Westbard Self Storage, Limited Site Plan Amendment No. 82017011A

- Request to revise the front and rear building setbacks and confirm the Parcel 1 Parkland Dedication area
- IM Zone
- Current use: Active construction site
- Located at 5204 River Road, Bethesda, MD
- 0.98 gross acres
- Applicant: Bethesda Self Storage Partners, LLC
- Acceptance date: April 14, 2020
- Review Basis: Chapter 59

Figure 3– Front Setback Exhibit. Blue line shows setback per approved data table; redline shows proposed.

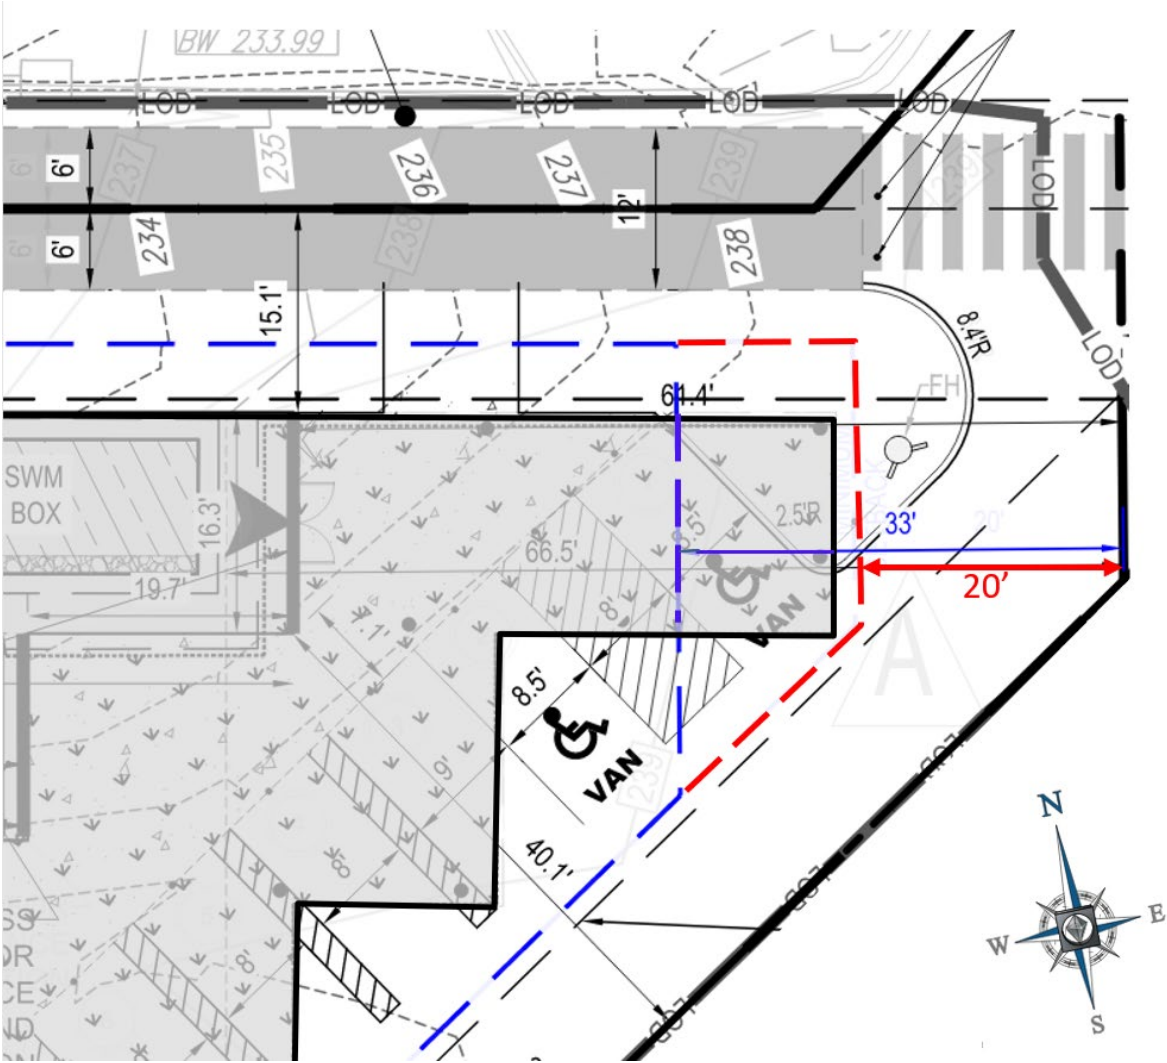
The front setback figure (eastern setback on narrowest portion of building closest to the Capital Crescent Trail) is proposed to decrease by thirteen feet from an approved minimum of 33 feet, to a minimum of 20 feet. The front setback is being corrected to fully address the building layout/overhang as originally proposed but erroneously described in the Applicant’s data table. The revised setback is still significantly in excess of the minimum 10-foot setback required by the zone.

Figure 4– Rear Setback Exhibit.
 Blue dashed line shows setback per approved data table; solid redline shows proposed.
 Yellow area highlights the setback change.

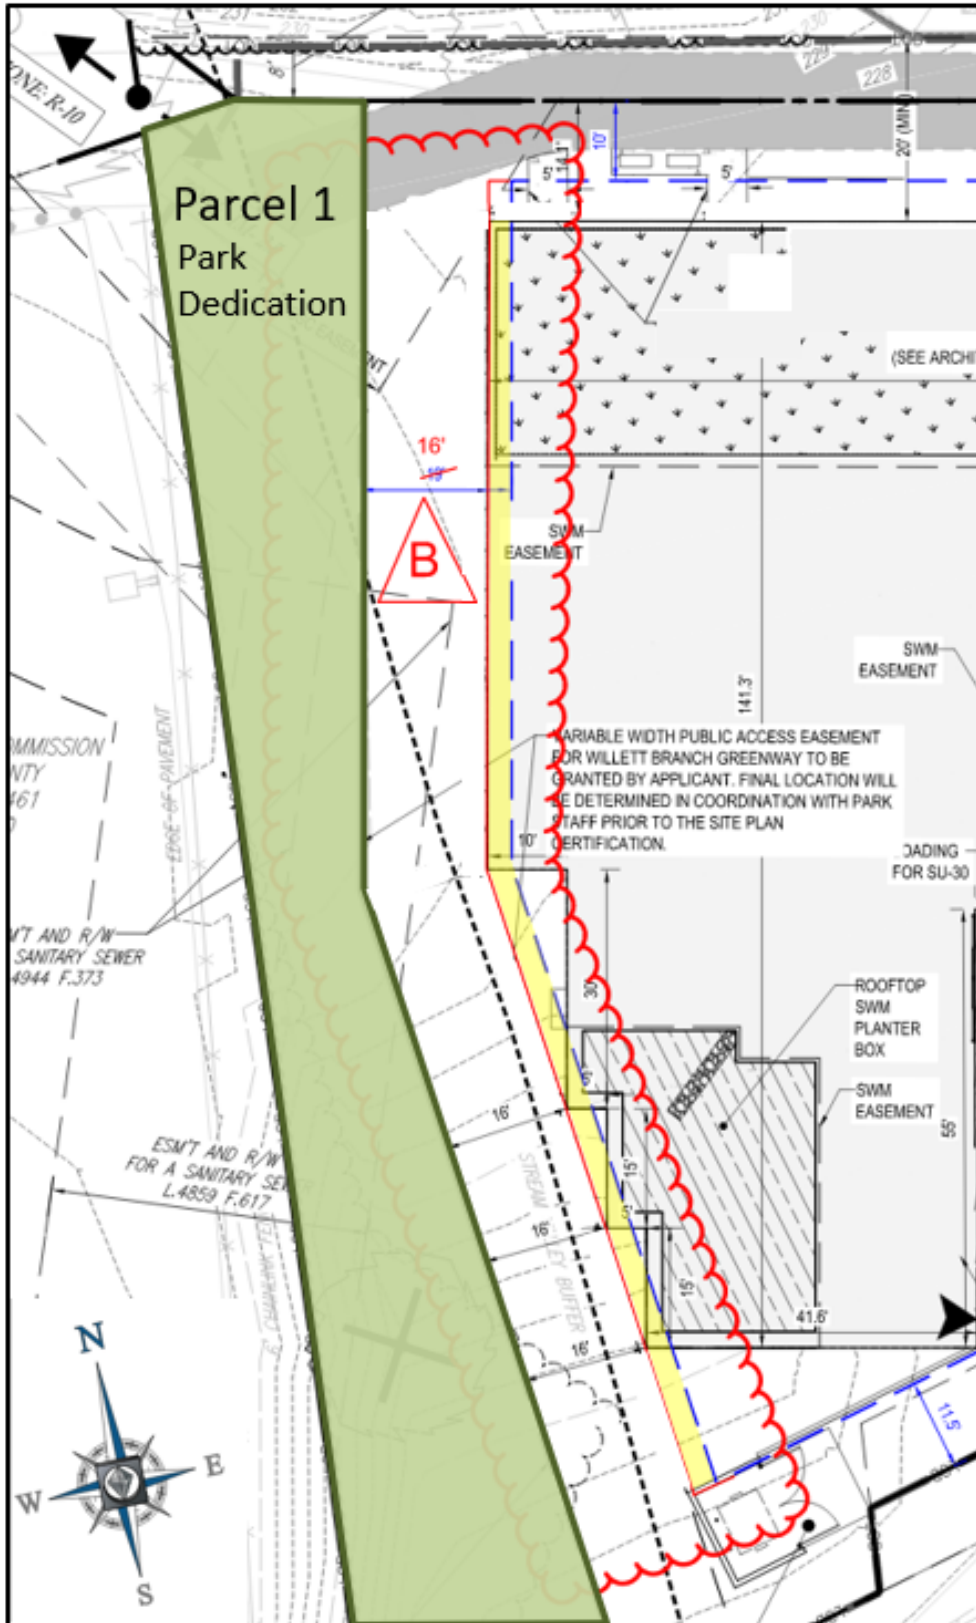
The setback figures for the west side of the building (closest to the stream buffer) could not be precisely determined at the time of the original Planning Board hearing because the extent of the Park dedication for Parcel 1 had not yet been established (Preliminary Plan Condition No. 18). Now that the extents of the dedication have been finalized, the revised rear setback reflects the dedication and proposes to reduce the rear setback, from 19 feet, to 16 feet. The revised setback is still significantly in excess of the minimum 10-foot setback required by the zone.
